Access Compliance Report

Public Rights-of-Way

Intersection ID: 23277	Main Street: S_TRYON_ST	Cross Street: CAROWINDS_BV	Location: SW
ADA ID: F47ADC41403E	Ramp Type: PerpDiag	Initial Pass/Fail: Fail	Overall Compliance: No
			Severity Score: 13.75

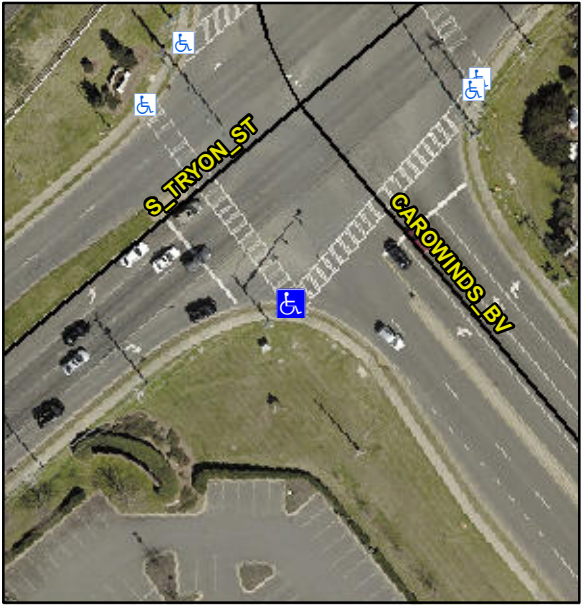
Codes/Mitigation Info/Possible Solution			Field Measurements/Component Compliance		
	Possible Solutions:		Compliance	Description	Data
	Remove & Replace Curb Ramp With Two New Directional Ramps or Equivalent.		No	Ramp Length (in)	66.0
			Yes	Ramp Width (in)	48.0
			N/A	Flare Type LT	N/A
			N/A	Flare Slope LT (%)	N/A
			N/A	Flare Traversable LT?	N/A
			N/A	Landing Length (in)	N/A
			N/A	Landing Width (in)	N/A
			N/A	Landing Slope (%)	N/A
			N/A	Landing X Slope (%)	N/A
<p>Surveyor Notes:</p> <p>N/A</p> <p>PROW/ADA:</p> <p>R304.2.2, R304.5.3</p>			N/A	Flare Type RT	N/A
			N/A	Flare Slope RT (%)	N/A
			N/A	Flare Traversable RT?	N/A
			N/A	DWS Provided?	N/A
			N/A	DWS Contrast?	N/A
			N/A	DWS Length (in)	N/A
			N/A	DWS Full Width?	N/A
			N/A	DWS Offset (in)	N/A
			N/A	Gutter Ponding?	N/A
			N/A	Gutter Lip Ht (in)	N/A
<p>Total Cost:</p> <p>\$ 3200.00</p>			Yes	Painted X Walk1?	Yes
				X Walk 1 Direction	To NE
			N/A	X Walk 1 Width (in)	113.0

X Walk 1 Slope (%)	1.9
				X Walk 1 X Slope (%)	2.5
			N/A	Ramp inside XWalk1?	Yes
				Road Slope (%)	2.0
				Road X Slope (%)	2.3
			N/A	Any Obstructions?	N/A
				Obstruction Type	
<p>Street 1 Name</p> <p>CAROWINDS BV</p> <p>Stop Condition-Street 2</p> <p>Signal</p> <p>Street 2 Name</p> <p>S TRYON ST</p> <p>Stop Condition-Street 1</p> <p>Signal</p>			N/A	Clear Space?	N/A
			N/A	Clear Space to XWalk (in)	N/A
			N/A	Storm Grate/Utility Hazard?	N/A
				Storm Grate/Utility Type	
			N/A		N/A
			Yes	Surface Condition? (G/P)	Good
